# UNITED STATES PATENT AND TRADEMARK OFFICE

APPLICATION NO.	FILING DATE	FIRST NAMED INVENTOR	ATTORNEY DOCKET NO.	CONFIRMATION NO.
10/712,974	11/13/2003	Bernhard Jakob	964-031963	7350
28289 7590 09/25/2007 THE WEBB LAW FIRM, P.C. 700 KOPPERS BUILDING 436 SEVENTH AVENUE PITTSBURGH, PA 15219			EXAMINER CIRIC, LJILJANA V	
			ART UNIT 3744	PAPER NUMBER
			MAIL DATE 09/25/2007	DELIVERY MODE PAPER

**Office Action Summary**

## **DETAILED ACTION**

Figure 2a (Prior Art)

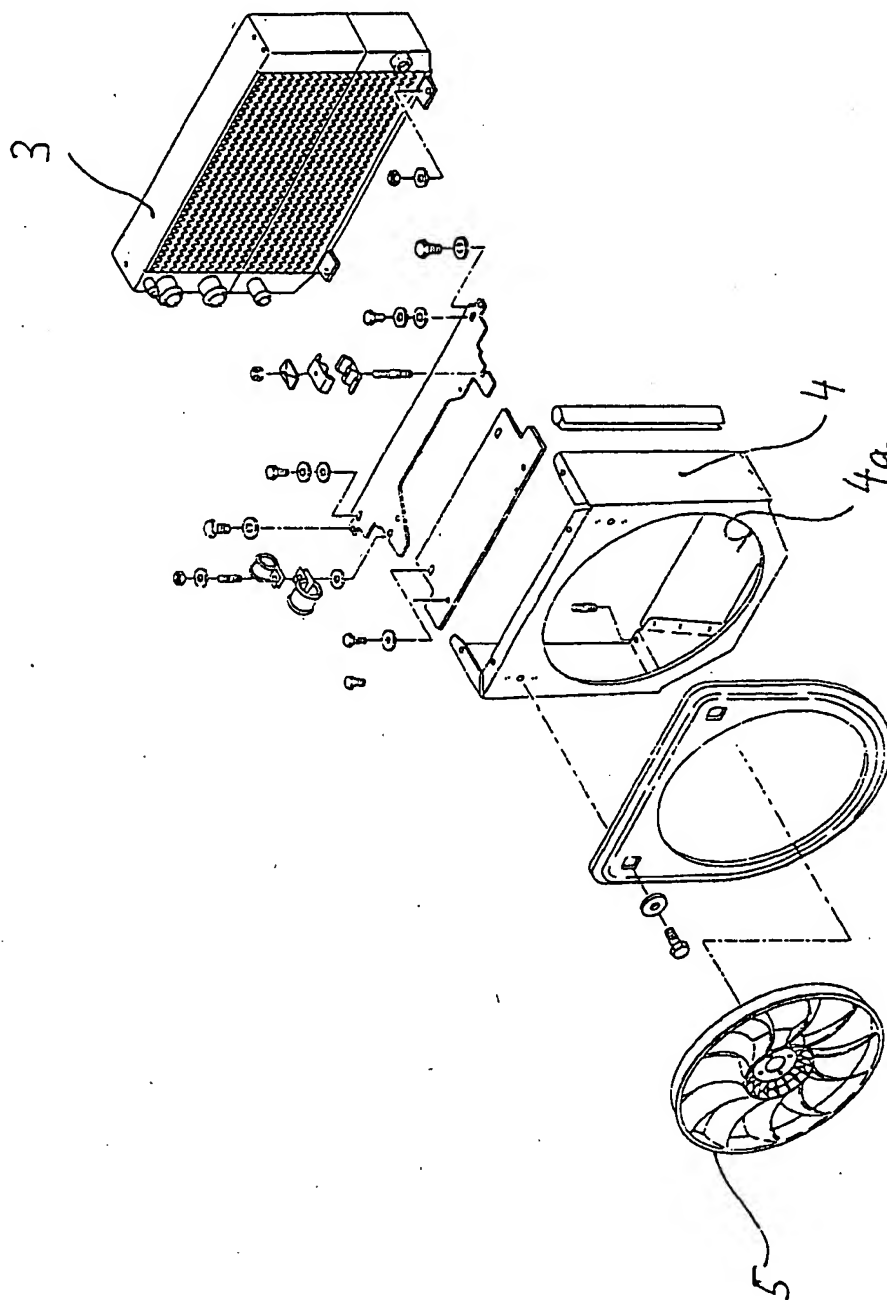
not approved.  
LVC  
1-7-07

Figure 2C (Prior Art)

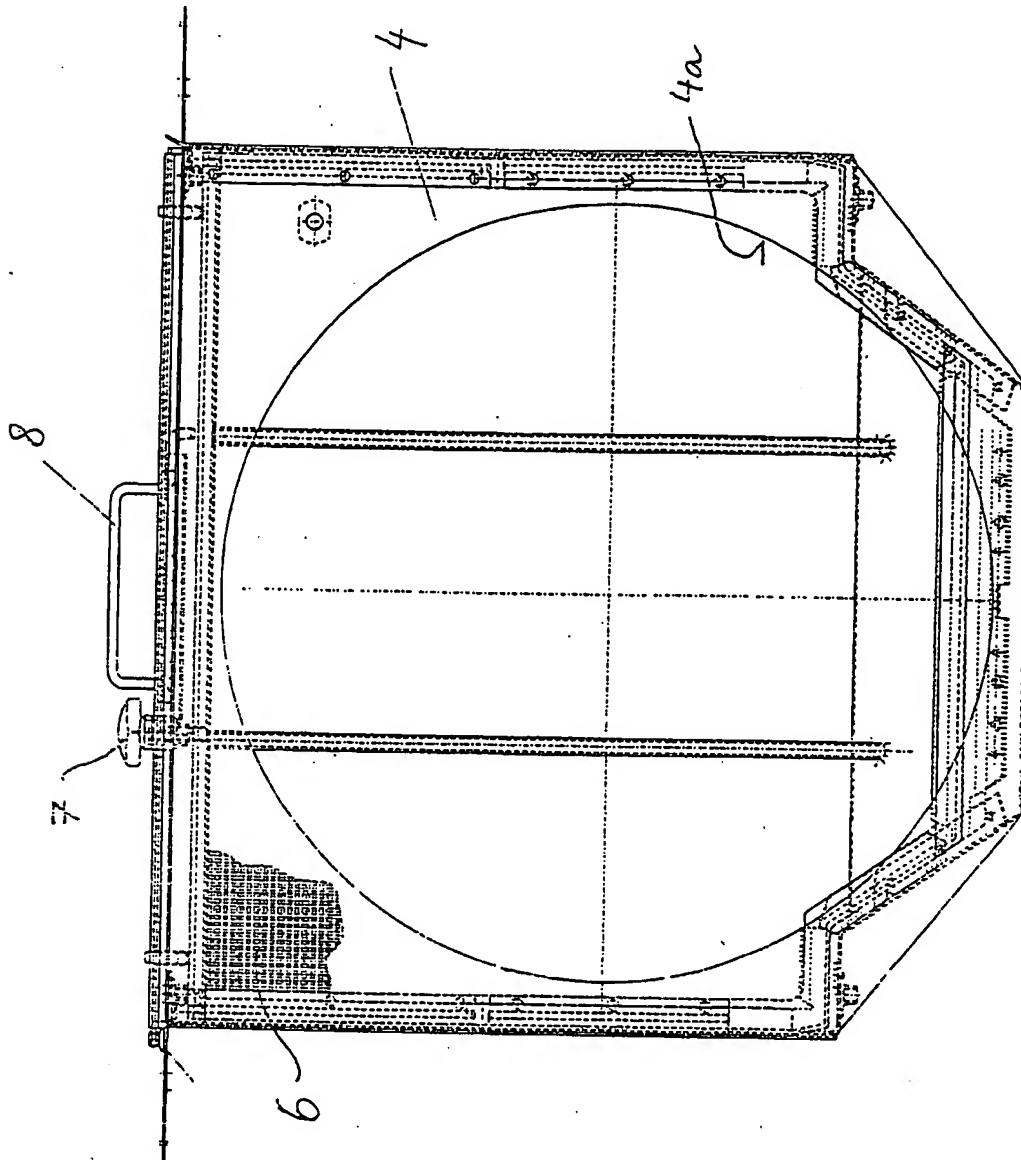
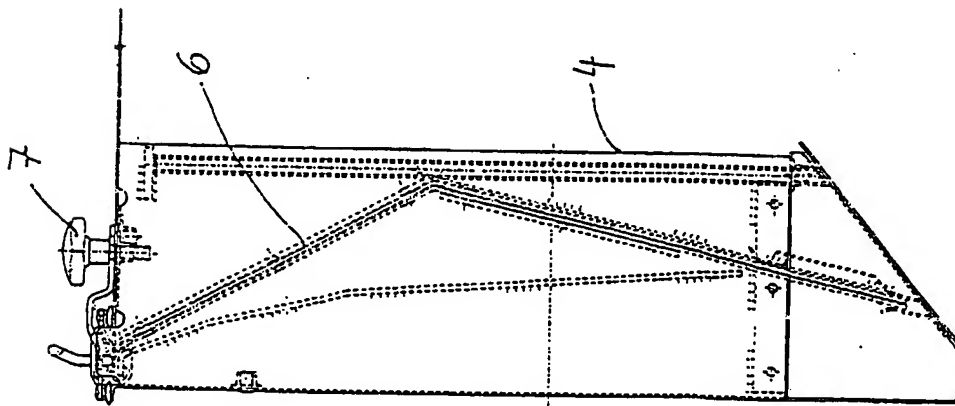
Not approved.  
LRC  
1-7-07

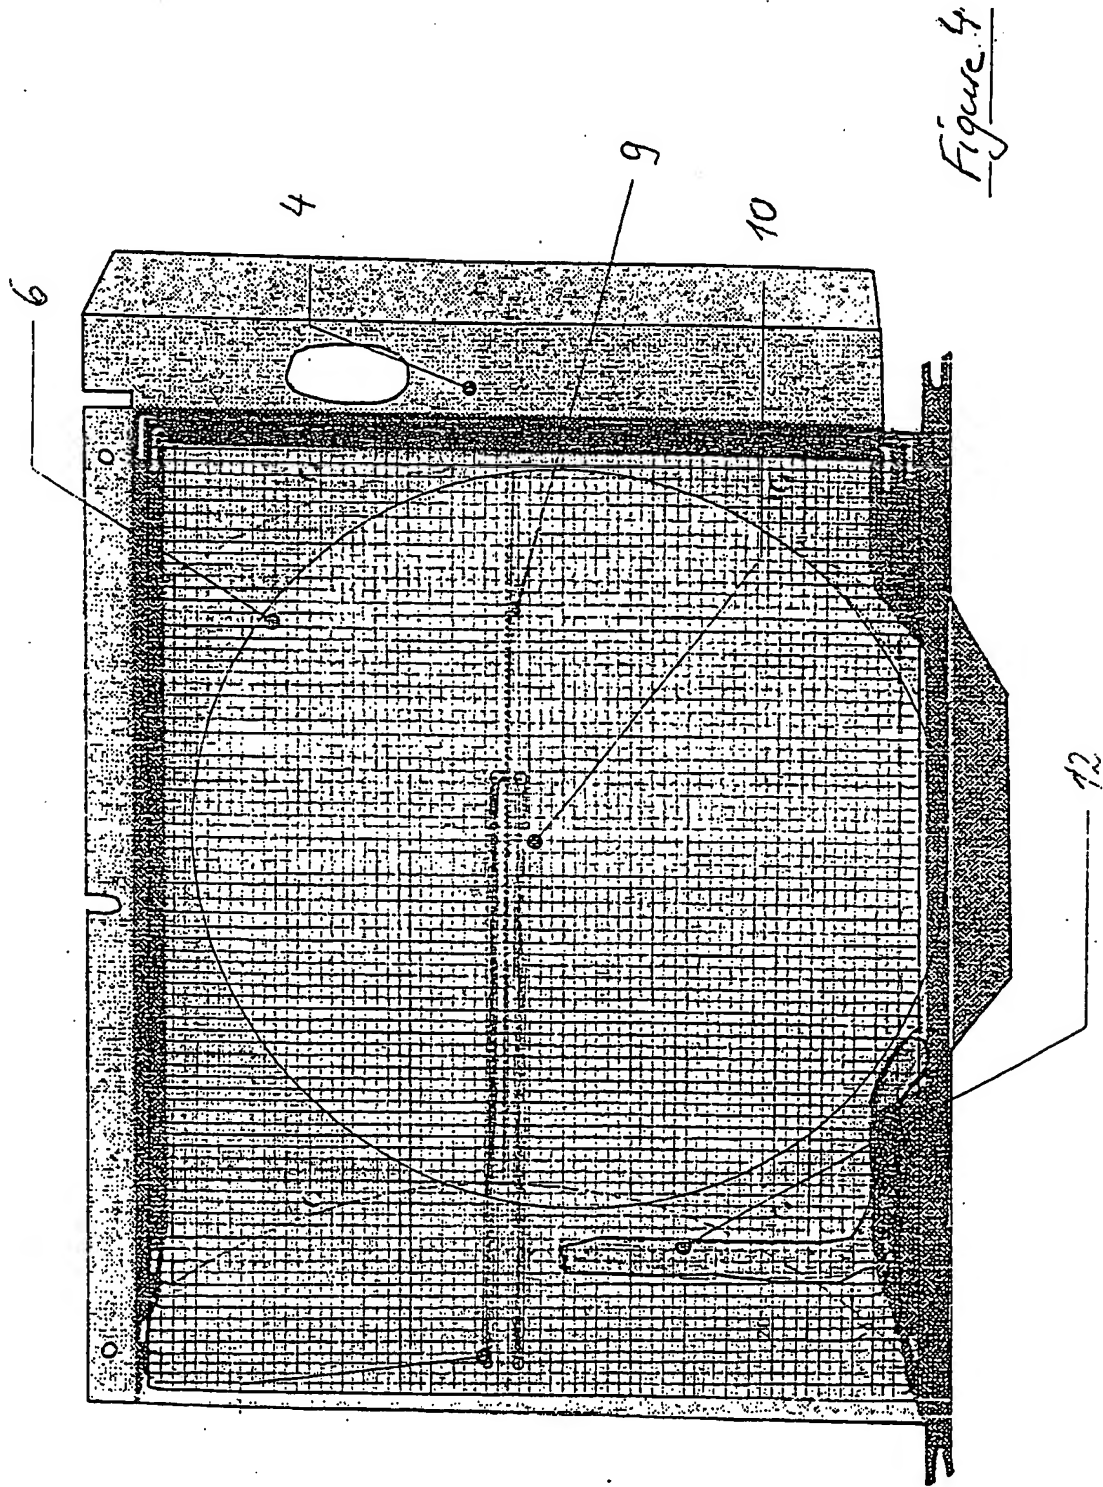
Not approved.  
AKC  
1-7-07
